ENGINEERING DIRECTIVE

**REVISIONS TO THE CONSTRUCTION STANDARD DRAWINGS ON
PRECAST MEDIAN BARRIER FOR TEMPORARY TRAFFIC CONTROL**

The purpose of this Engineering Directive is to formally notify **ALL** Department Engineering Personnel of a change to the Construction Standard Drawings 401.15.1 and 401.15.2.

REPLACES DRAWING 401.15.2

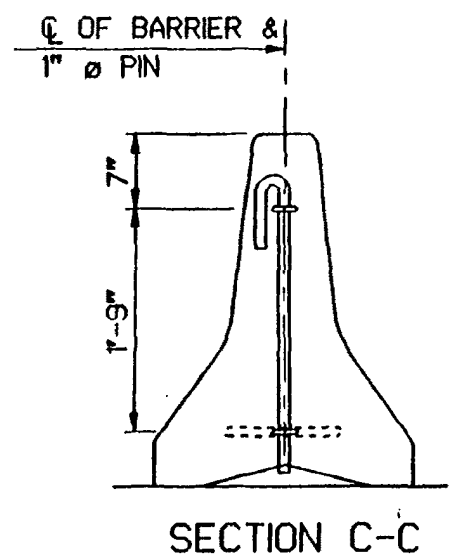
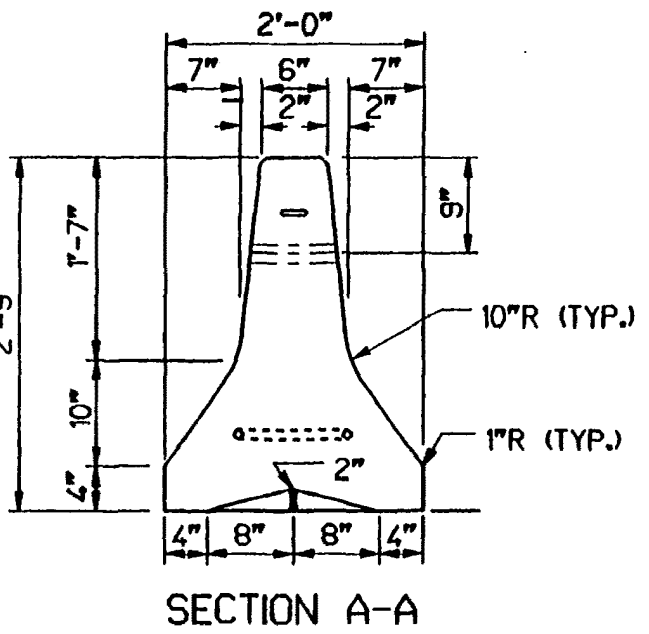
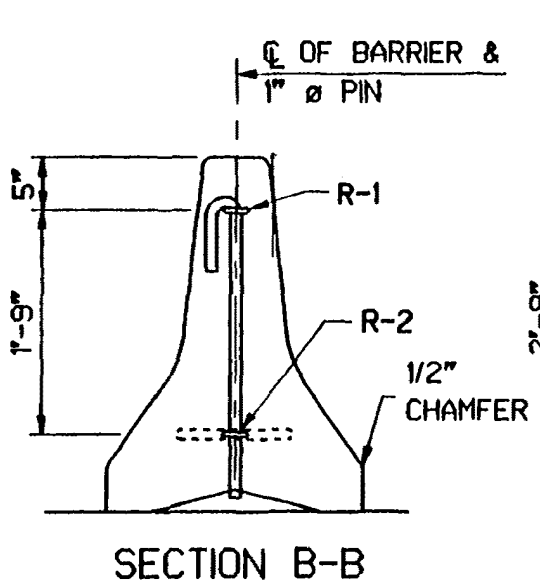
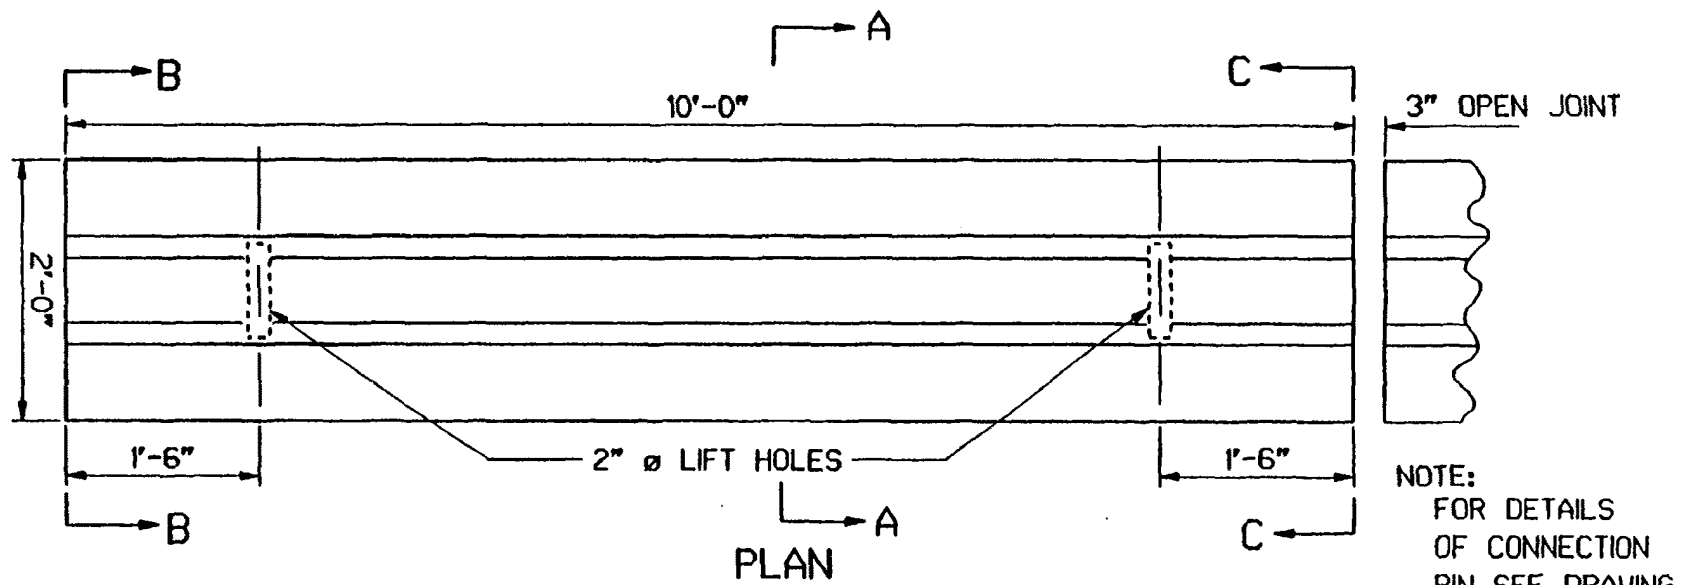
NOTE:
THE ENTIRE PIN JOINING ADJACENT BARRIERS MUST BE COMPLETELY
WITHIN THE CROSS-SECTION OF THE TEMPORARY CONCRETE BARRIER.

CONNECTION PIN DETAIL

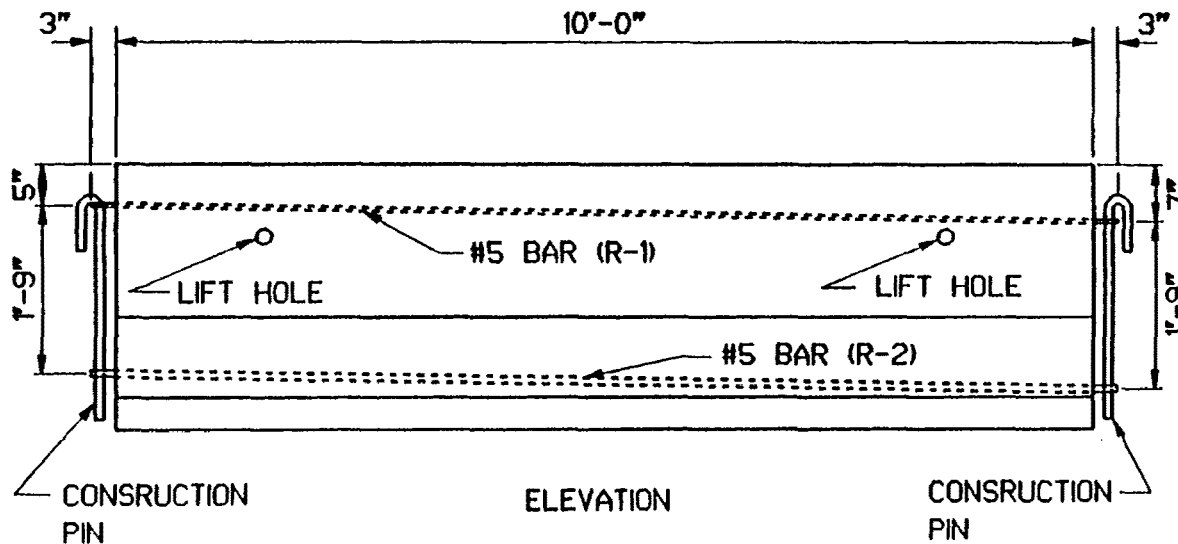
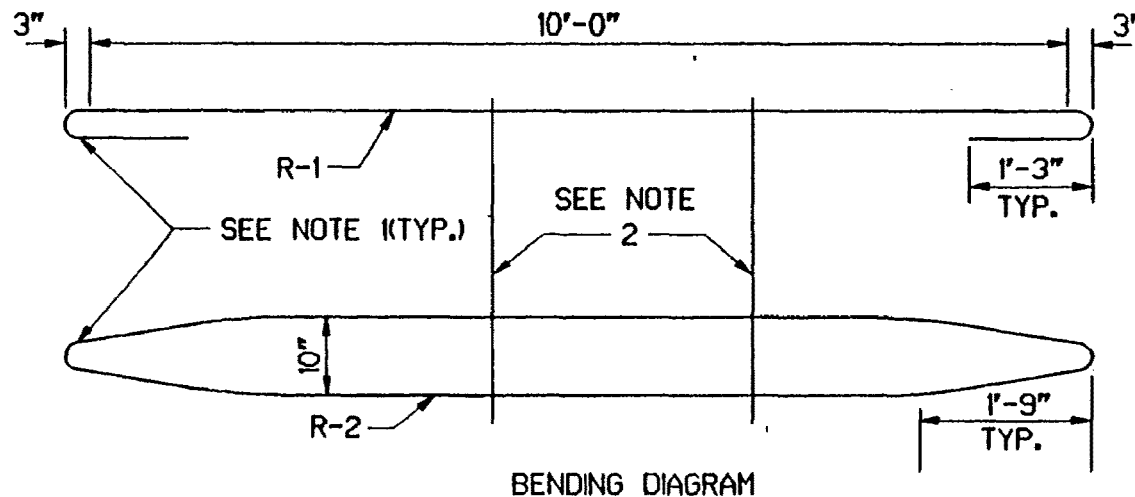
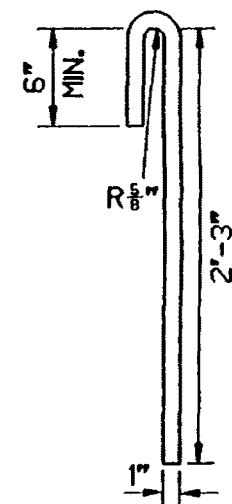
Effective immediately, in all projects, the connecting pin is to be completely contained within the cross section of the barrier. Notes on Drawing 401.15.1 require the pin to be heat bent to ensure a smooth bend and prevent shattering of the pin.

1. BEND REBARS AROUND A 1 3/8" \varnothing ROD.
2. BARS R-1 AND R-2 SHALL BE FABRICATED CONTINUOUSLY, OR AT THE OPTION OF THE CONTRACTOR. THE BARS MAY BE FABRICATED WITH 15" MINIMUM LAPS AT THE LOCATIONS SHOWN.
3. PIN CONNECTION SHALL BE COMPLETELY WITHIN THE CROSS-SECTION OF THE BARRIER.
4. THE 1" \varnothing PIN SHALL BE HEAT BENT TO A 5/8" RADIUS (1 1/4" DIAMETER).
